Access Compliance Report

Public Rights-of-Way

(Curb Ramps)

Intersection ID: 12220	Main Street: E_6TH_ST	Cross Street: N_COLLEGE_ST	Location: S
ADA ID: 83C750197386	Ramp Type: Perp	Initial Pass/Fail: Fail	Overall Compliance: No
Severity Score: 13.75			
Codes/Mitigation Info/Possible Solution		Field Measurements/Component Compliance

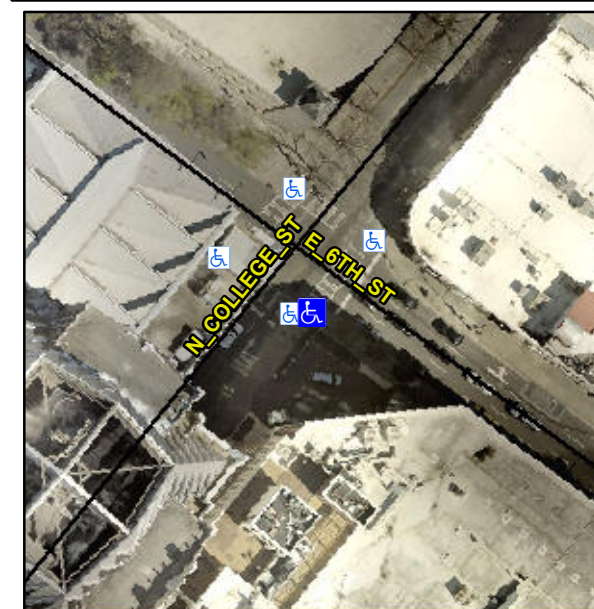
Not Found, R304.2.2, R304.5.3

Compliance	Description	Data	Compliance	Description	Data
N/A	Ramp Length (in)	72.0	No	Ramp Slope (%)	8.7
Yes	Ramp Width (in)	55.0	No	Ramp XSlope (%)	2.4
N/A	Flare Type LT	N/A	N/A	Flare Type RT	N/A
N/A	Flare Slope LT (%)	N/A	N/A	Flare Slope RT (%)	N/A
N/A	Flare Traversable LT?	N/A	N/A	Flare Traversable RT?	N/A
N/A	Landing Length (in)	N/A	N/A	DWS Provided?	N/A
N/A	Landing Width (in)	N/A	N/A	DWS Contrast?	N/A
N/A	Landing Slope (%)	N/A	N/A	DWS Length (in)	N/A
N/A	Landing X Slope (%)	N/A	N/A	DWS Full Width?	N/A
N/A	Landing Curb? (Y/N)	N/A	N/A	DWS Offset (in)	N/A
N/A	Shared Landing?	N/A			
N/A	Gutter Ponding?	N/A	N/A	Gutter Slope (%)	N/A
N/A	Gutter Lip Ht (in)	N/A	N/A	Gutter X Slope (%)	N/A
N/A	Painted X Walk1?	Yes	N/A	Painted X Walk2?	N/A
	X Walk 1 Direction	To NE		X Walk 2 Direction	N/A
N/A	X Walk 1 Width (in)	103.0	N/A	X Walk 2 Width (in)	N/A
	X Walk 1 Slope (%)	2.1		X Walk 2 Slope (%)	N/A
	X Walk 1 X Slope (%)	1.8		X Walk 2 X Slope (%)	N/A

Remove & Replace Entire Ramp.
